**COMMISSION OF ARCHITECTURAL REVIEW
STAFF REPORT
August 28, 2018 Meeting**

12. **COA-037278-2018** (M. Jarreau)

**804 North 22nd Street
Union Hill Old and Historic District**

Project Description: **Construct a new single family dwelling.**
Staff Contact: **C. Jones**

1925, republished 1952, Sanborn Map of the 800 block of North 22nd Street

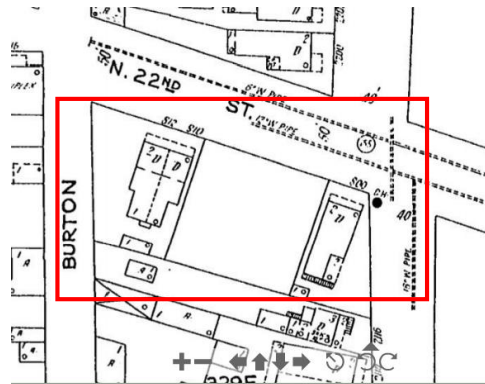
Where the adjoining buildings have different setbacks, the setback for the new building should be based on the historical pattern for the block

The historic pattern for the block is shown below.
